RESPONSE TO REQUEST FOR ADDITIONAL INFORMATION

APR1400 Design Certification

Docket No. 52-046

RAI No.: 268-8308
SRP Section: SRP 19
Application Section: 19.1.
Date of RAI Issued: 10/02/2015

Figure 19.1-62 LPSD Level 1 Event Tree – Loss of Offsite Power (LP) in POS 1

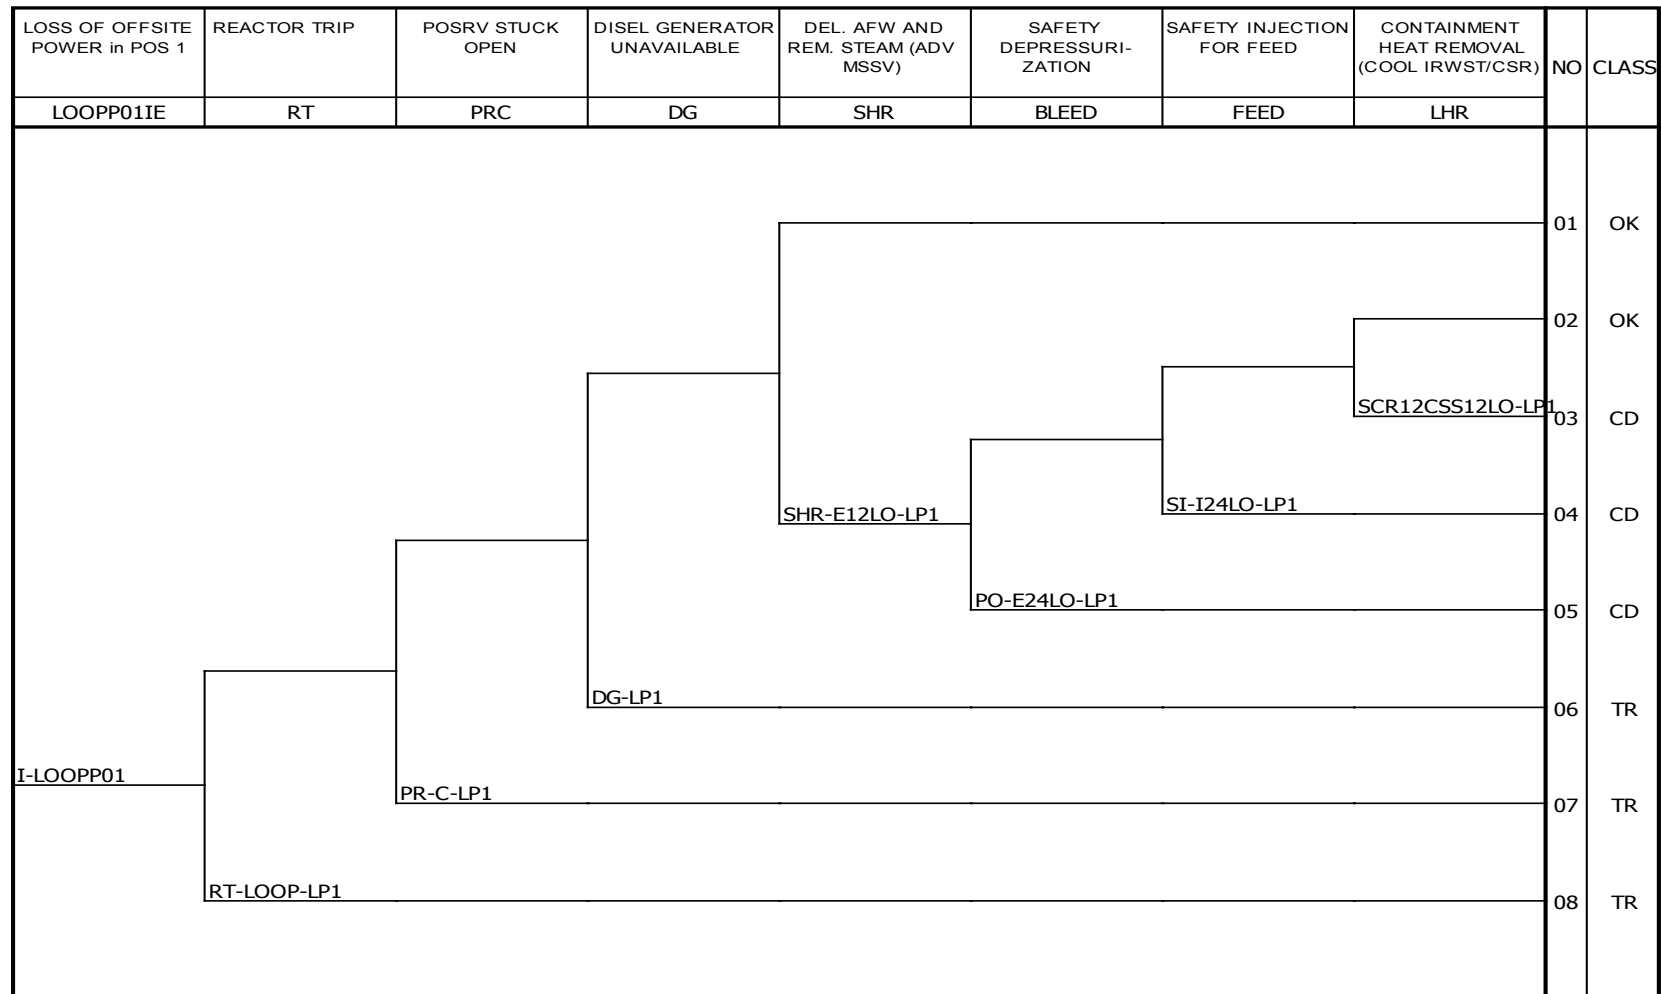
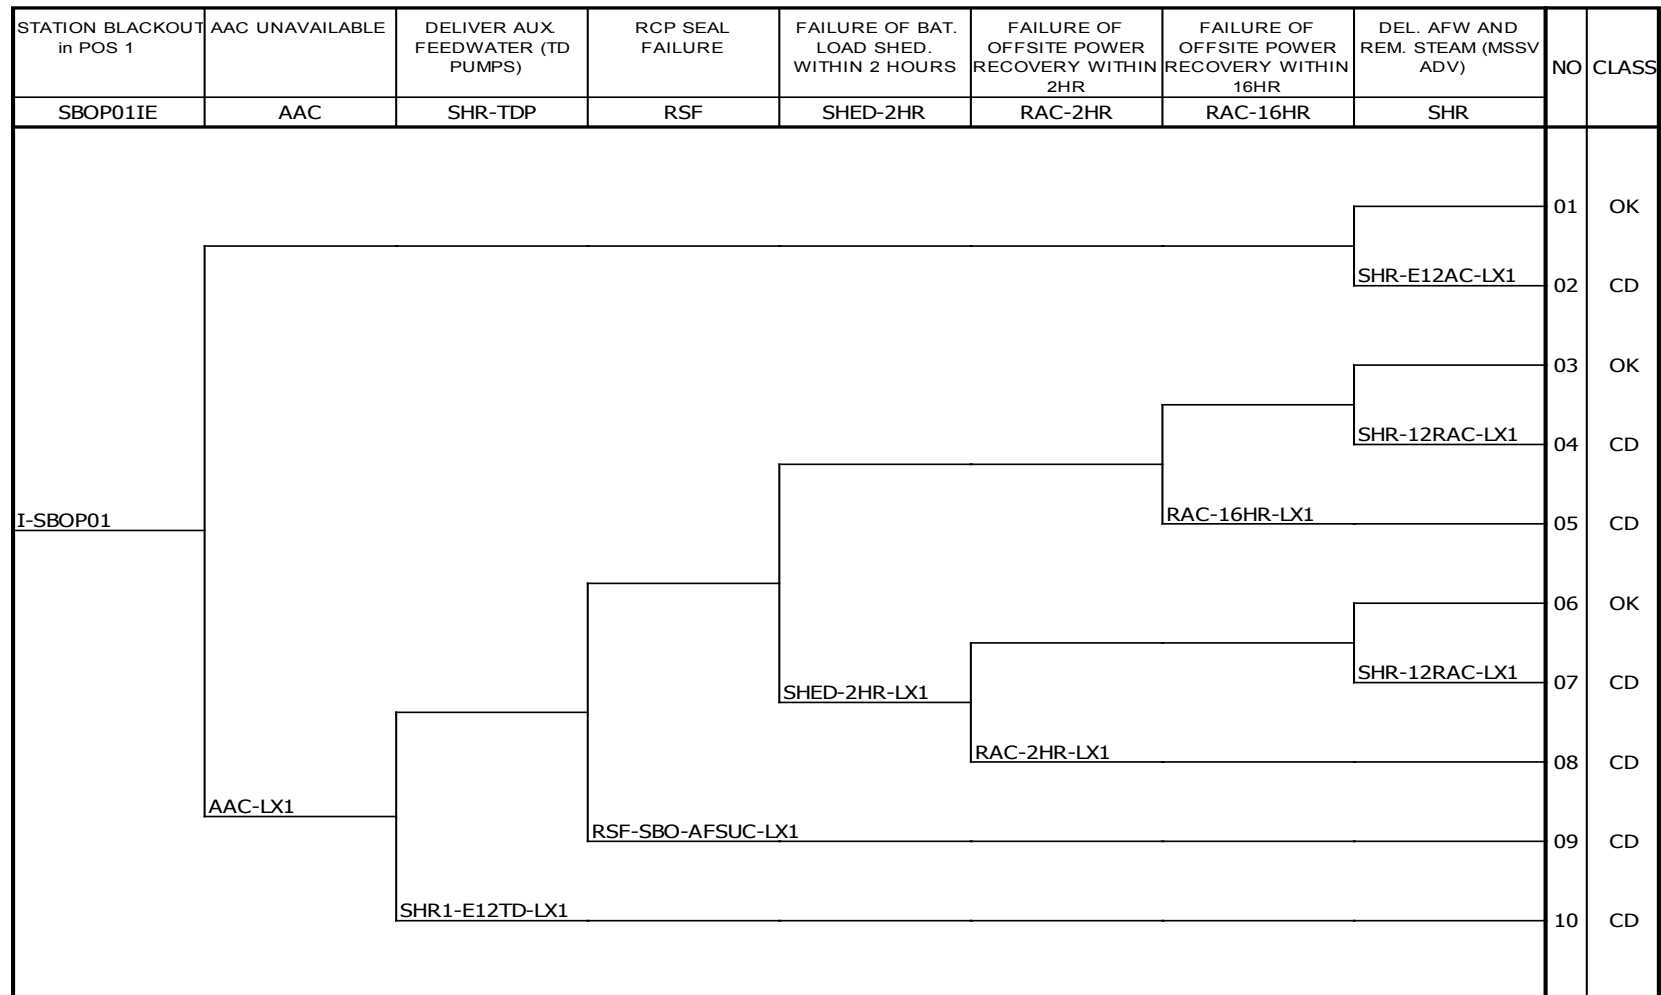
10 CFR 52.47(27) requires that a standard design certification applicant provide a description of the design specific PRA and the results. Design Control Document Section 19.1.6, appears to be missing event trees for all plant operational states other than plant operational state 5, which represents mid-loop conditions. However, the plant response to a loss of decay heat removal (DHR) is significantly different if the reactor coolant system (RCS) is intact versus an open RCS. To provide an example of how the different plant operational states were modeled in the probabilistic risk assessment (PRA), the staff is requesting that the applicant add the event trees for all plant operational states for the initiating event, loss of the operating train of the shutdown cooling (SDC) system. The staff considers these low power shutdown (LPSD) event trees part of the PRA results. These event trees will allow the reader to understand the varying plant response to a shutdown initiating event given the different plant operational states.

The twelve (12) event trees for POS 5 are included as Figures 19.1-52 through 19.1-63 in DCD 19.1. In response to this RAI, the low power and shutdown (LPSD) event trees for all plant operational states will be added to the DCD. The supporting discussion will also be revised.

The POS 5 LPSD event trees in Figures 19.1-52 through 19.1-63 will be supplemented to present the event trees for all plant operating states in Figures 19.1-52 through 19.1-208 and also figure for LPSD Containment Event Tree will be changed to Figure 19.1-209 as shown in the Attachment 1

~~The LPSD event trees for POS 5, which occurs during mid-loop operation, are contained in Figure 19.1-52 through Figure 19.1-63.~~

The LPSD event trees for all plant operational states (POSs) are presented in Figures 19.1-52 through 19.1-208. The LPSD containment event tree is presented in Figure 19.1-209.
